Planning Commission
September 19, 2023 - 6:00 PM
233 South Main Street, Monroe, Ohio

1. Case No. 2023-9-5— Consideration of Site Plan Application for Ohana Car Wash

- Nick Dobbs, on behalf of NJDS LLC, has submitted a site plan application for a car wash facility at the corner of State Route 63 and Gateway Boulevard.
- The applicant is proposing a 5,000 square foot car wash. The car wash is a 130 FT long single wash bay capable of washing five to six cars at one time.
- The site is approximately 3.1 acres currently zoned C-2 General Commercial.

GATEWAY CARWASH
CITY OF MONROE
TURTLECREEK TOWNSHIP
WARREN COUNTY, OHIO

LOCATION PLAN

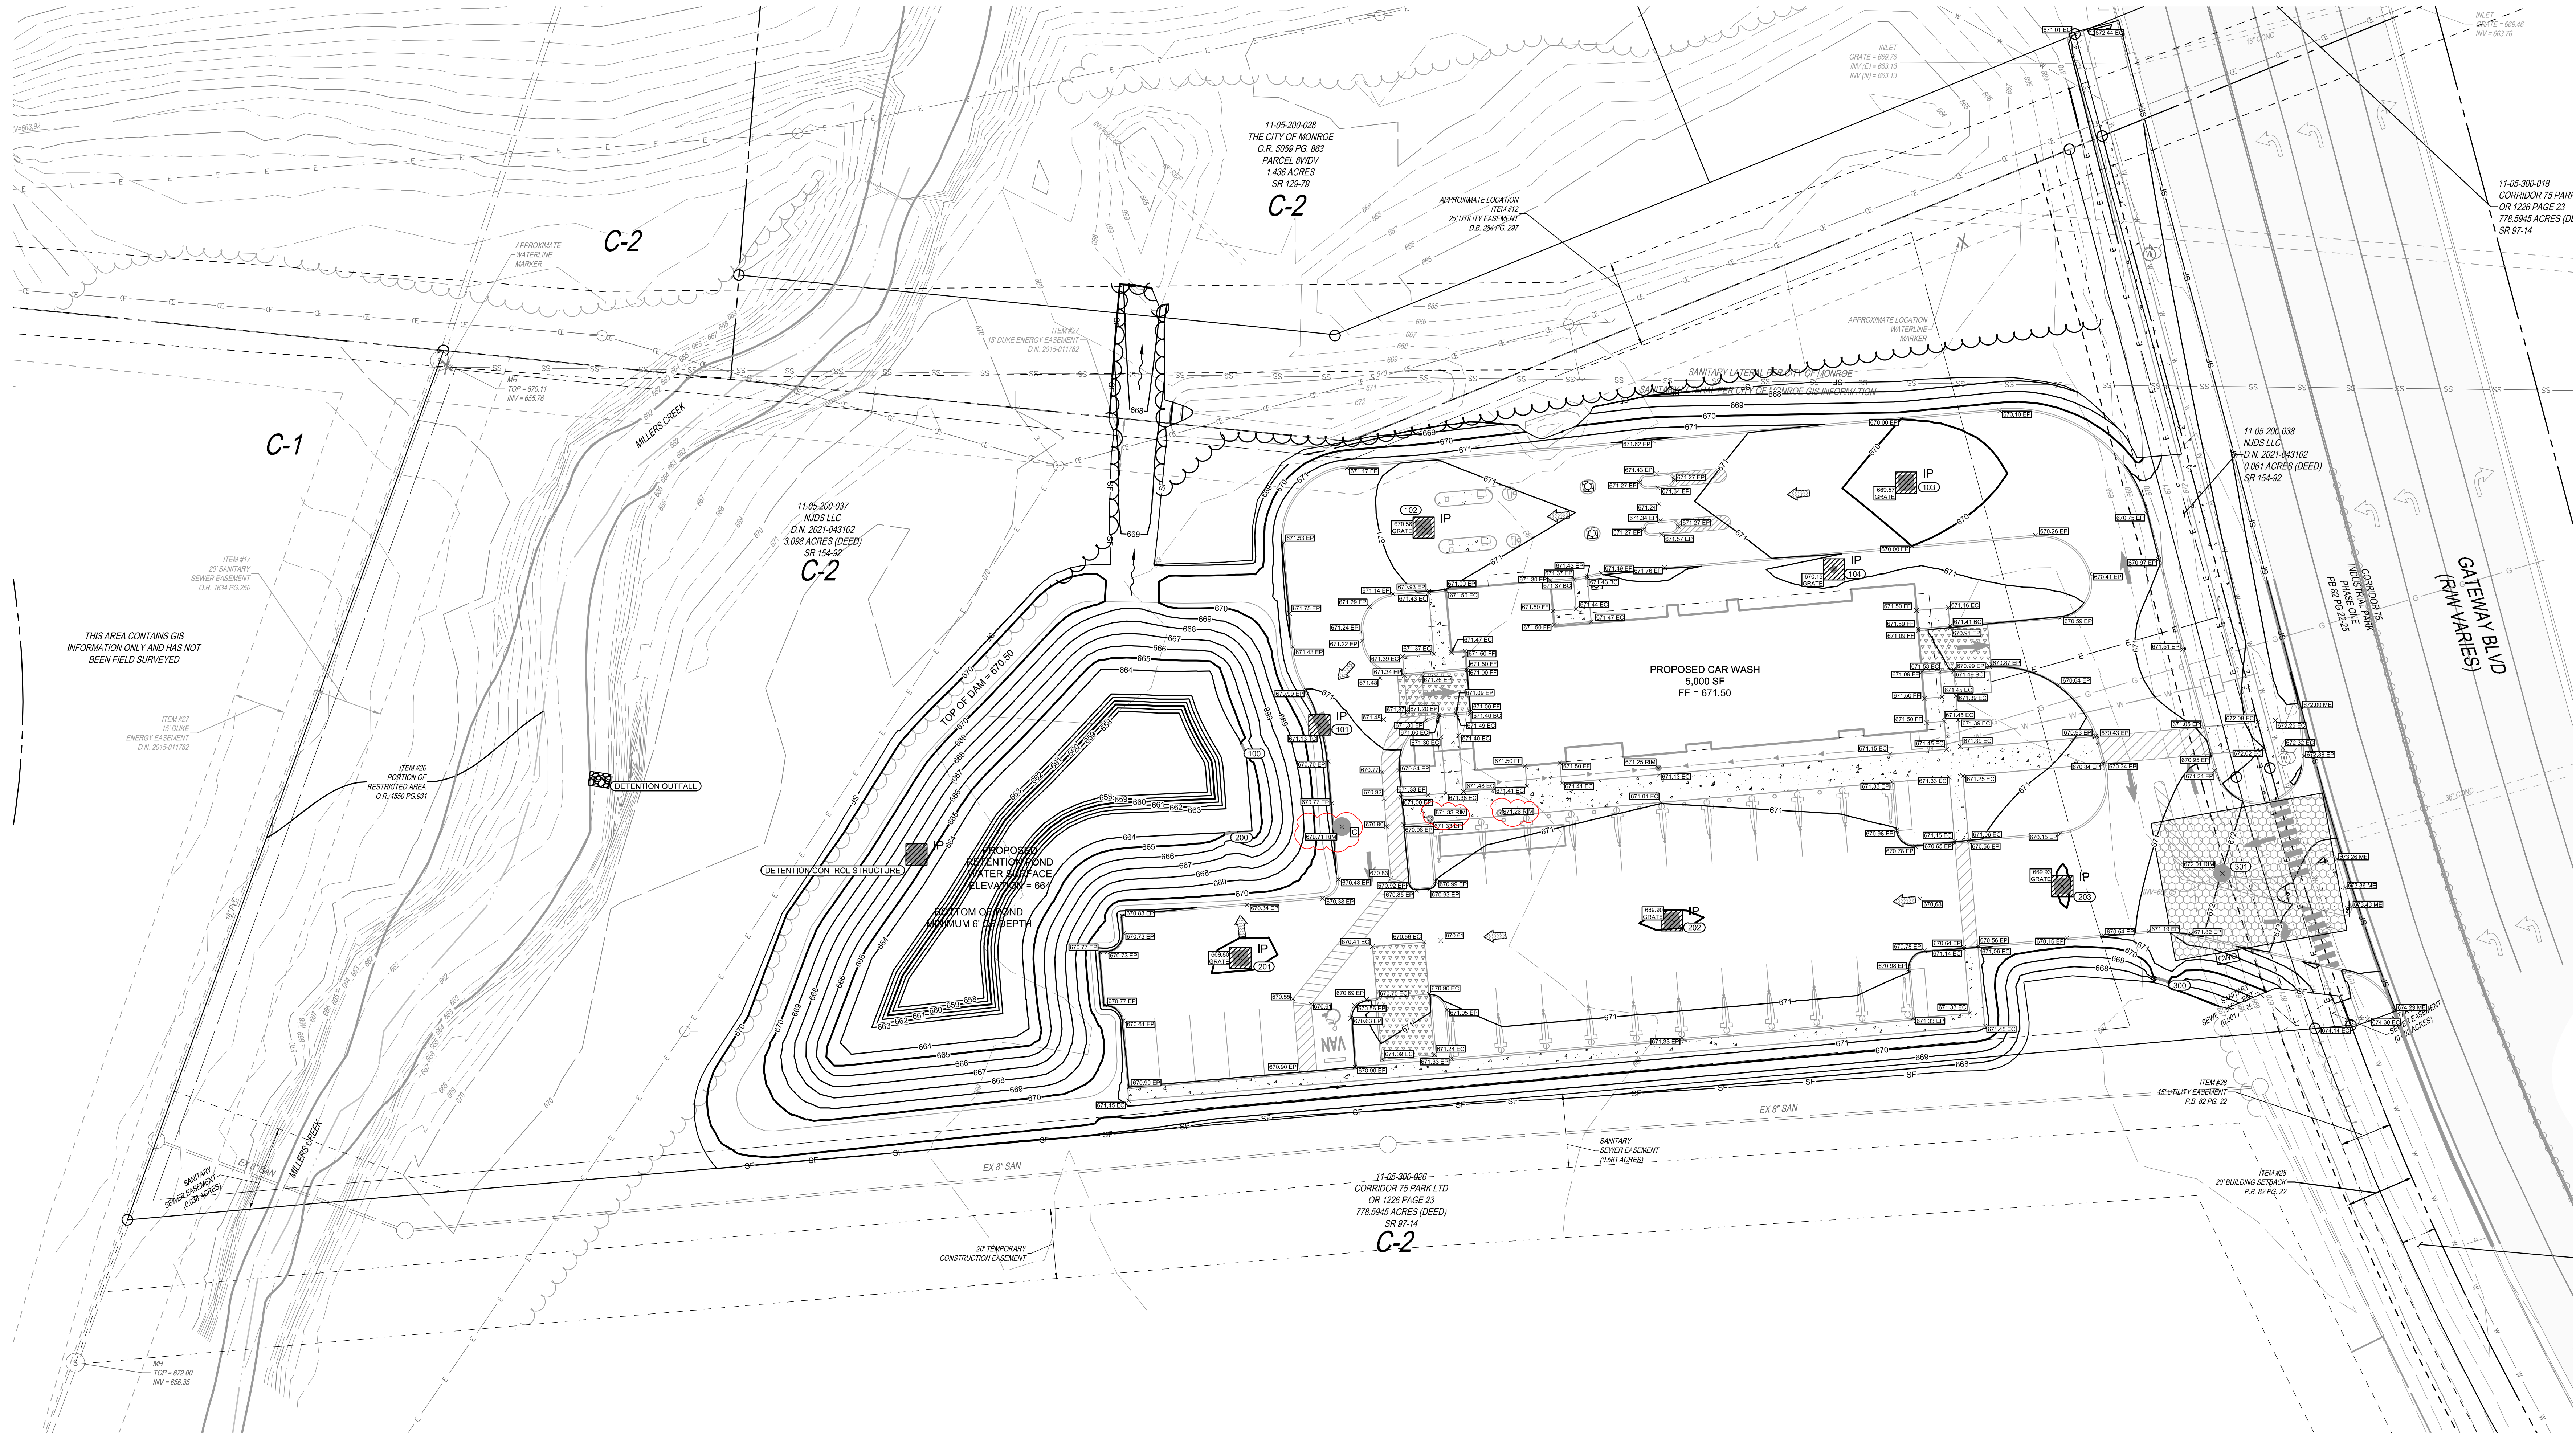
- A minimum 5-foot walk is required along private and public streets.
 1. A 5-foot walk has been shown along Gateway Blvd, but none is shown along State Route 63.
- Please provide sidewalk access to the office entrance to avoid pedestrian interference with oncoming stack lane traffic (see below):

1. The length along SR63 is approximately 500 FT, requiring 13 trees.
 2. The plan does not show any street trees along SR63. Please revise.
- **Architectural–**

- Staff recommends approval of the site plan application with the following conditions:
 - Discussion and decision regarding the sidewalk requirement along the site's ROW frontage on State Route 63.

- Discussion and decision on the street tree requirement along State Route 63.
 - The applicant will revise architectural plans to address staff comments.

2 SOUTH ELEVATION

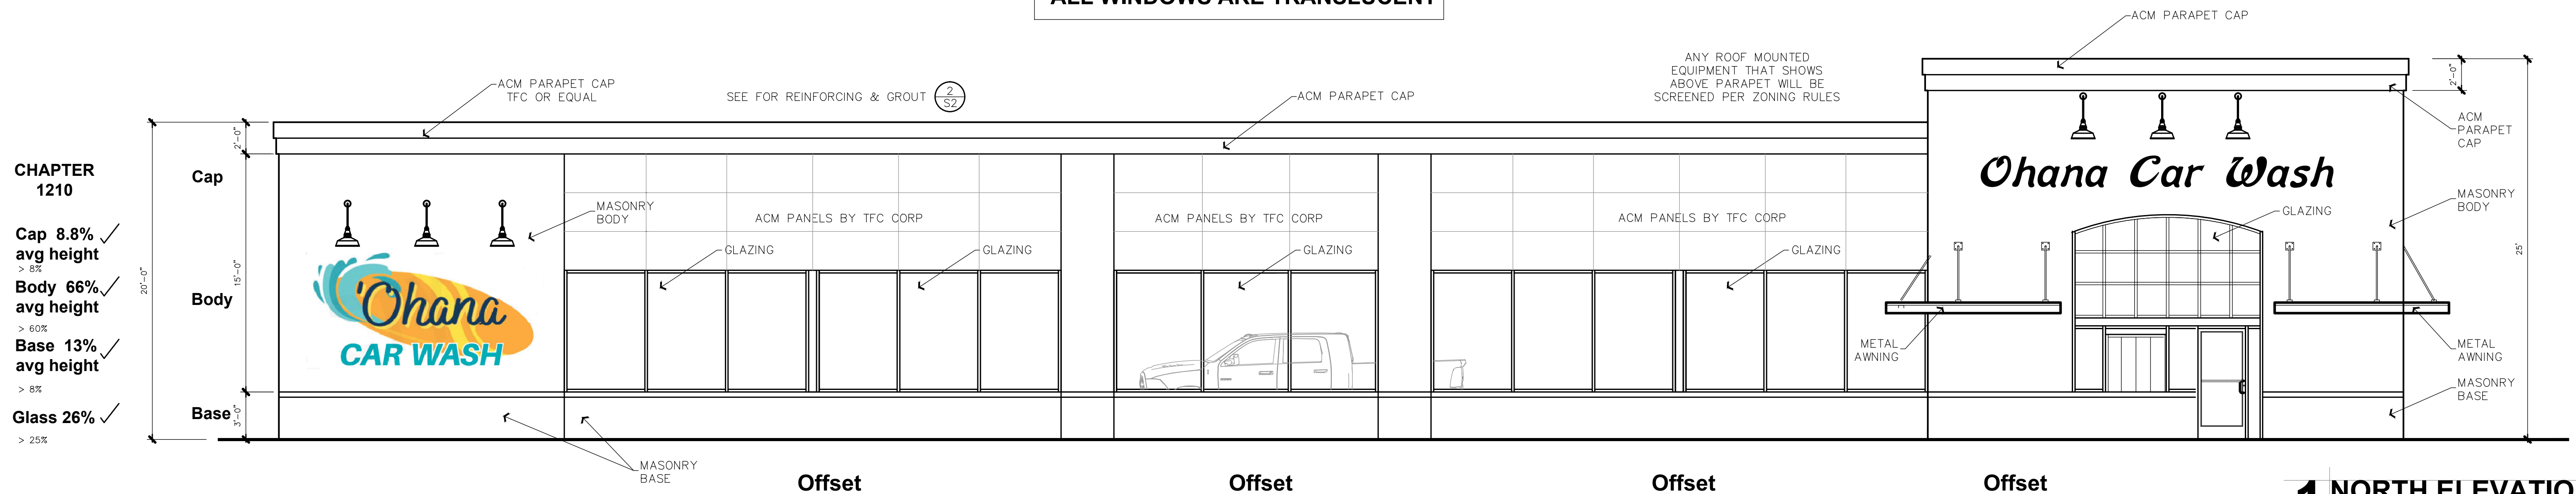
1. Please address this requirement on the south side of the building.
 2. Service doors and wall mounted equipment must be painted to match the building. Please revise.

- The applicant will screen the service doors on the south side of the building as approved by staff.
 - As a reminder, all landscaping must meet all minimum species and size requirements and be detailed appropriately on the plan.
